Our Reference: 6037354

PA2015-4832 - Modeina Estate - Stage 13 – Amended Engineering Plans - Approval Letter

MODEINA STAGE 13

MUNICIPALITY:	CITY OF MELTON
PROJECT:	MODEINA STAGE 13
DETAILS:	INTERSECTION DETAILS - SHEET 2 of 2
SCALE	1:200
LEVEL DATUM	A.H.D.
SHEET	4 OF 17
DRAWING No.	1275/13/NE/4

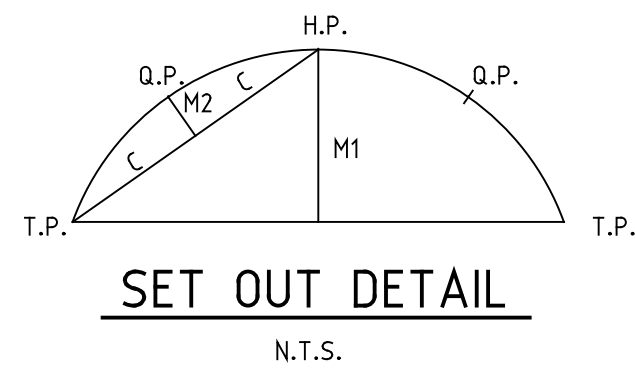
REF.	REVISION	DATE	APPD.
C4	ADDED SPLITTER ISLAND	06/03/20	M.C.
C3	REMOVED TACTILES AND LINEMARKING ON SHARED PATH	4/3/20	M.C.
C2	MINOR AMENDMENTS	20/12/18	J.B.
C1	COUNCIL REQUIREMENTS	7/11/18	J.B.
P2	STAGE BOUNDARY AMENDED	4/7/18	J.B.

TYPICAL SPILTTER ISLAND CROSS SECTION
REFER TO MCC 305
N.T.S.

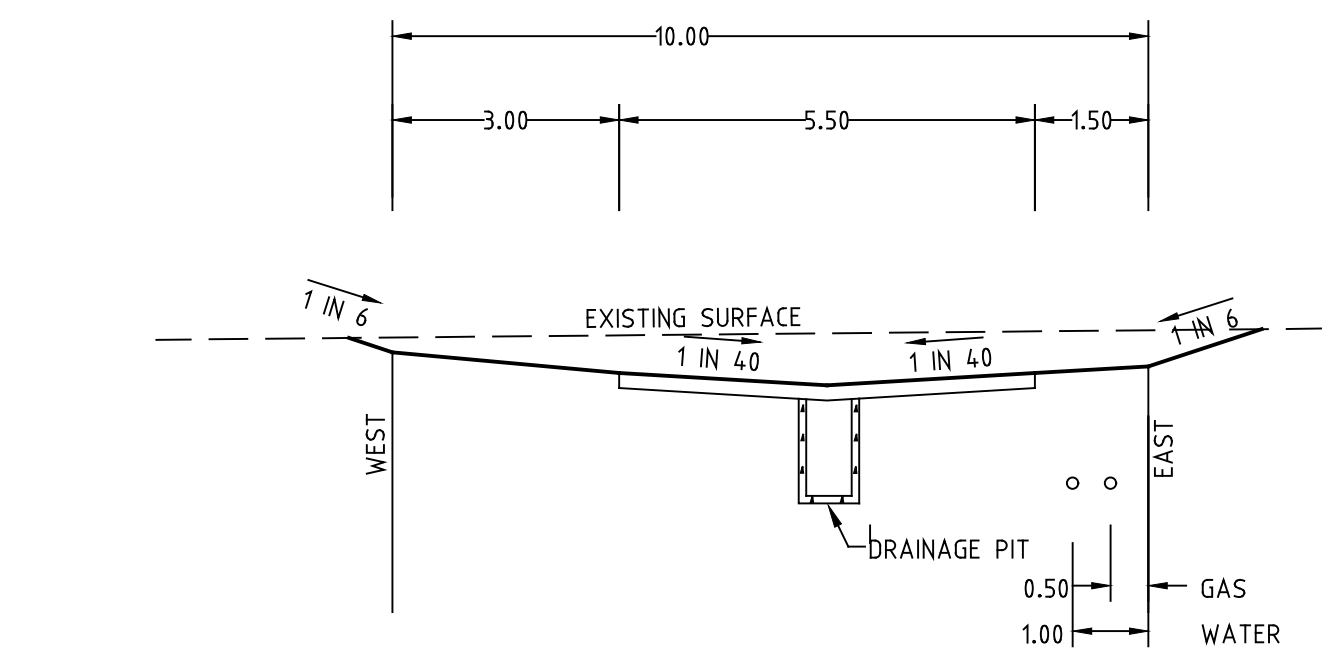
REF.	REVISION	DATE	APPD.	LEGEND	20.06	EXISTING SURFACE LEVEL	DRAWN: J.BEVERIDGE	MUNICIPALITY: CITY OF MELTON	SCALE 1:500
C2	ADDED SPLITTER ISLAND DETAIL	4/3/20	M.C.	WATER MAIN	PROPERTY INLET PIT	FINISHED LEVEL (TITLE BOUNDARY)	DESIGNED: J.BEVERIDGE	PROJECT: MODEINA STAGE 13	LEVEL DATUM A.H.D.
C1	COUNCIL REQUIREMENTS	7/11/18	J.B.	GAS MAIN	EXISTING PROPERTY INLET PIT	DESIGN TOP OF BATTER LEVEL	CHECKED: L.PAPAZOIS	DETAILS: TYPICAL SECTIONS & KERB DETAILS	SHEET 6 OF 17
P2	STAGE BOUNDARY AMENDED	4/7/18	J.B.	ELECTRICITY CABLE	DRAIN AND PIT	DESIGN PAVEMENT LEVEL	AUTHORISED: T.DAVOLI		DRAWING No. 1275/13/NE/6
				TELECOM CABLE	EXISTING DRAIN AND PIT	EXISTING RIDGE LEVEL	DATE: DEC '15		C1
				WATER CONDUIT	SEWER LINE AND MANHOLE	EXISTING CONTOUR LINE & LEVEL			P2
				GAS CONDUIT	KERB AND CHANNEL	FILLING IN EXCESS OF 150mm			
				TELECOM CONDUIT	EXISTING KERB AND CHANNEL	CATCH DRAIN			
				HOUSE DRAIN	KERB TO BE REMOVED OFFSITE	EX. BATTER
